**RE: PART VIII – Urban Enhancement & Improvement – Ormonde Street,  
Kilkenny**

Chief Executive's Report on the Public Consultation Process  
for Ormonde Street Urban Enhancement and Improvement Works.

## **Ormonde Street - Urban Enhancement & Improvement Works**

**Re: Urban Enhancement and Improvement Works – Ormonde Street, Kilkenny.**

GENERAL LAYOUT  
SHEET 1 OF 2)

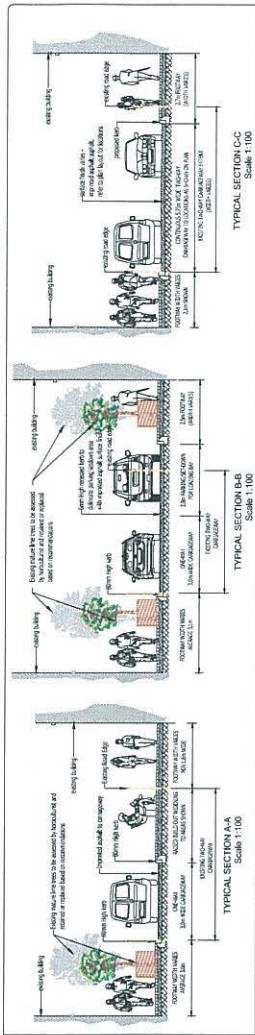
The crossing at the junction of Patrick St. and Ormond St. has been drawn on the plans as following a diagonal line. Currently there is a straight crossing at this point. This is safer for people with impaired vision than a diagonal crossing. If this change is made, a Long Cane user would be in danger of not finding the up-kerb on the far side, and could inadvertently walk down the middle of the road, instead.

**(a)** There is a short flight of steps shown in the plans, and a note saying that the guidelines for handrails in Part M of the Building Regulations will be followed. We assume that the guidelines for outdoor stairs in the Technical Guidance Document for Part M will therefore also be followed: colour-contrasted nosings on each step, steps of equal and appropriate height and depth, etc. This would also include the provision of tactile paving (Hazard Warning type) at the top and bottom of the steps.

When a footpath with a kerb-edge is installed on Ormond St., there should not be any need for bollards, as a kerb of a good height will deter motorists from parking on the footpath. Will the bollards therefore be removed?

It is not clear to us from the plans whether the existing drainage gully (quite shallow and wide, with brickwork) will be removed, when kerbs go in, and whether this will make it possible to have a wider footpath area.

In an image set into the plans, two pale grey benches are shown, standing on a pale grey path. NCBI recommends colour contrast between seating and the surface on which is situated, and against which it is seen.

The bollards shown in the pictures inserted onto the plans look excellent. We are assuming that they will be/are at least 1m in height. The black colour shows up well against the paler background, and the white stripes make them even more visible, especially in the dark. We hope that the white stripes will be light-reflective.

<b>Key Points Made</b>	<b>Response</b>
Overall welcome for the proposals subject to clarification on a number of items.	Noted
Queries if the pedestrian crossing at the junction of Ormonde Street and Patrick will continue to be a "straight" crossing.	The "straight" crossing as per existing location will be retained as part of the proposals. Due to design standards the only possible crossing at this junction is a courtesy crossing. Zebra Crossings and/or Light Controlled Crossings are provided in various other locations in accordance with design standards.
Queries recent removal of barrier at Ormonde Street and Patrick Street junction.	Barrier was in place originally to direct pedestrians to the appropriate crossing point and to prevent indiscriminate parking. Recent upgrade works have retained the two objectives above but without the need for the barrier. The remaining barrier will be removed assuming the Ormonde proposals are approved.

Existing tapered kerbs and steps at Ormonde Hotel cause difficulties for mobility and visually impaired people	This is acknowledged and is correct and the development will eliminate the tapering of the steps to achieve a more regular layout of steps. Levels will not permit the elimination of steps.
Compliments the efficient use of tactile paving outside Hibernian Hotel etc.	Noted.
Exiting Street Furniture is poorly located and makes Ormonde Street challenging.	A key aspect of the proposed scheme is to address the reasonably stated concerns regarding street furniture and the design will accommodate an inside/outside area for street furniture together with a bordered, designated and identifiable desire line for pedestrians free of any street furniture. All public lighting will be wall mounted.
Location of drainage gullies.	Gullies will be located off the public footpath and will not conflict with vulnerable road users and pedestrians.

Various measures to support the visually impaired	Some very practical and reasonable suggestions are made as to how the Scheme can be made compatible and complimentary to the needs of the visual and mobility impaired. Kilkenny County Council commits to engaging with Kilkenny Access Group/NCBI before and during the construction phase to address specific concerns raised in the submission.
